Exelon Generation Company, LLC
LaSalle County Station
2601 North 21st Road
Marseilles, IL 61341-9757

LaSalle County Station, Units 1 and 2
Facility Operating License Nos. NPF-11 and NPF-18
NRC Docket Nos. 50-373 and 50-374

Subject: 2003 Annual Radiological Environmental Operating Report -
Errata

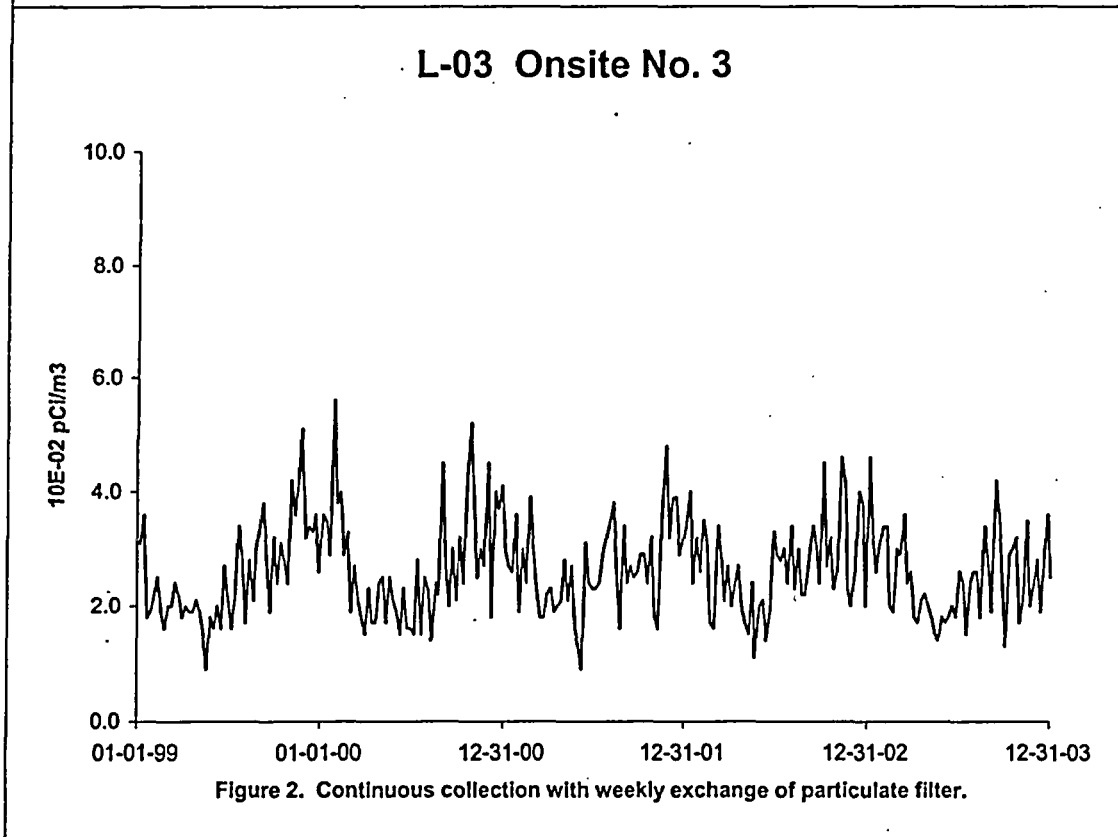
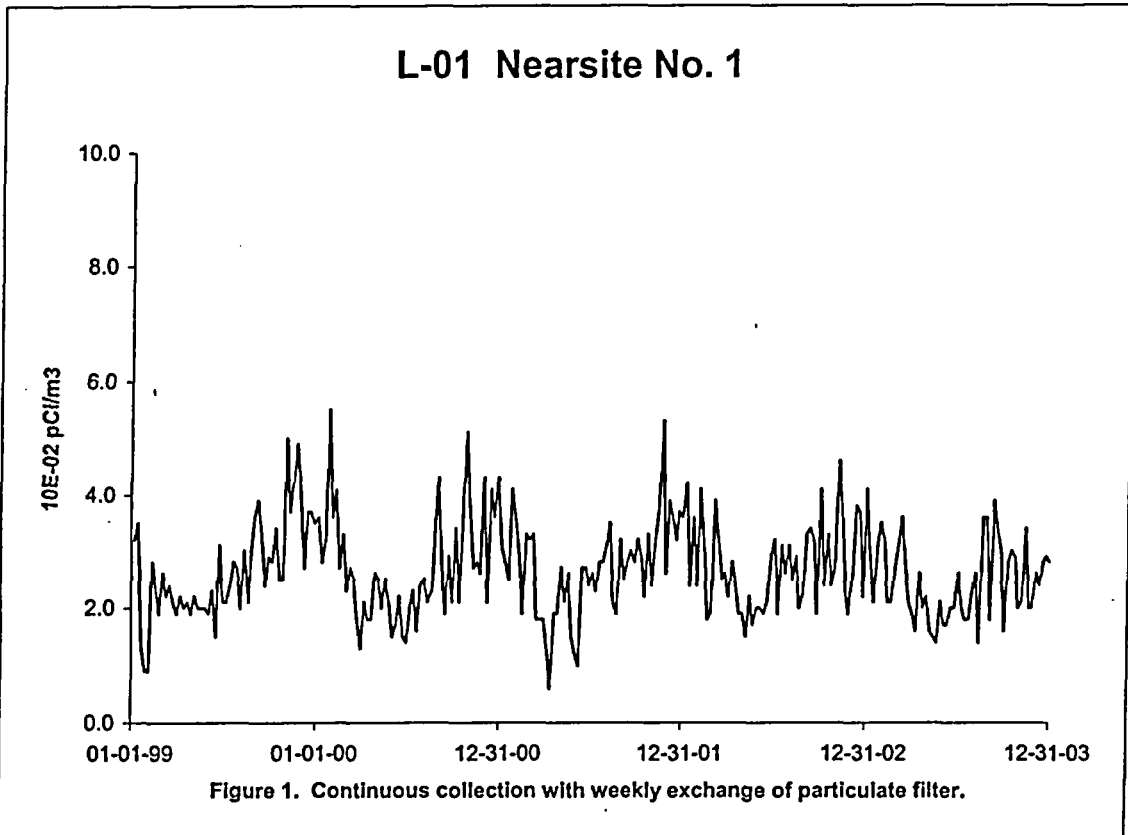
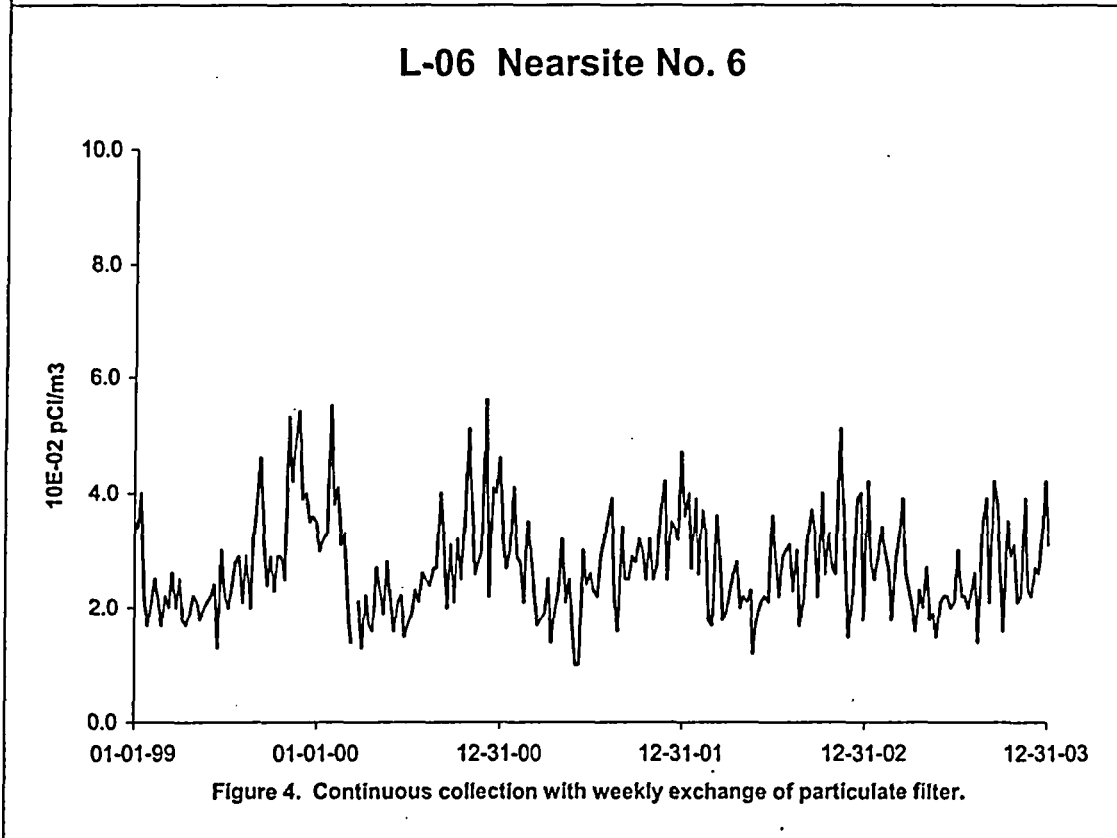
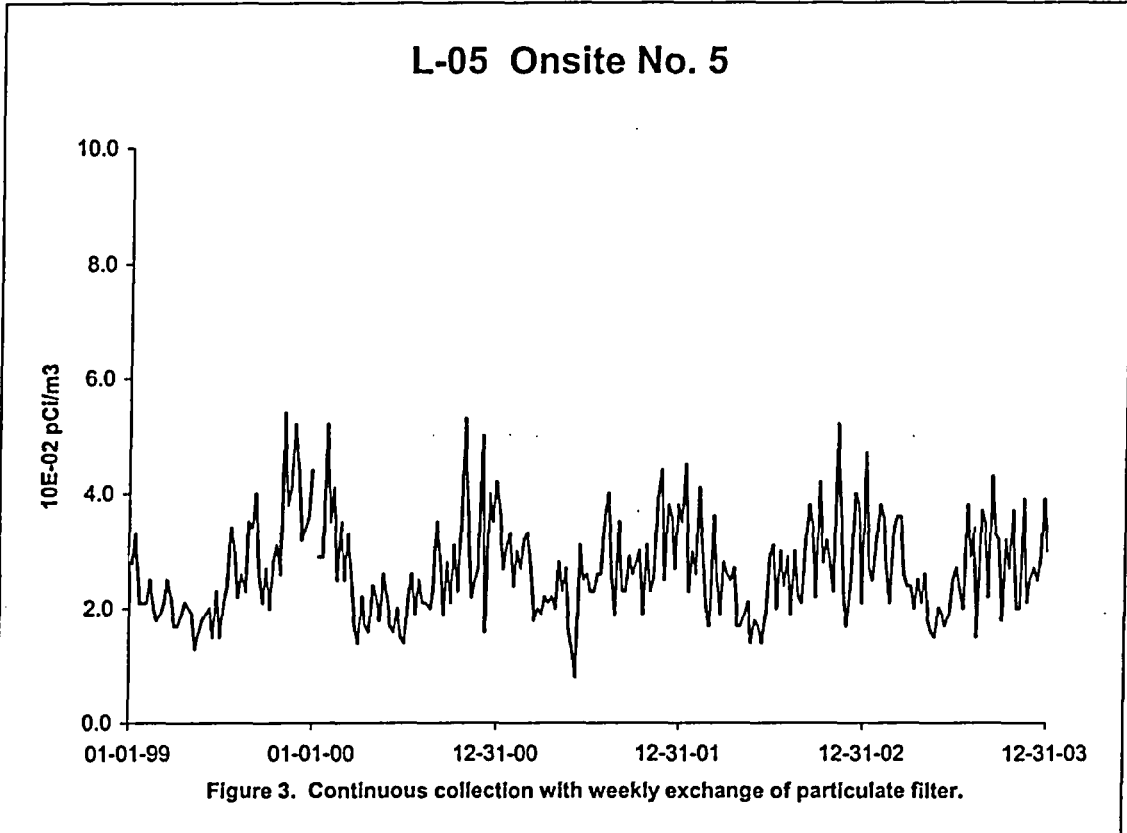
Enclosed are corrections to the referenced letter for Exelon Generation
Company (EGC), LLC, LaSalle County Station. This transmittal contains
corrections to figures 1 through 5 on pages III-41 through III-43. The original
figures contained erroneous dates.
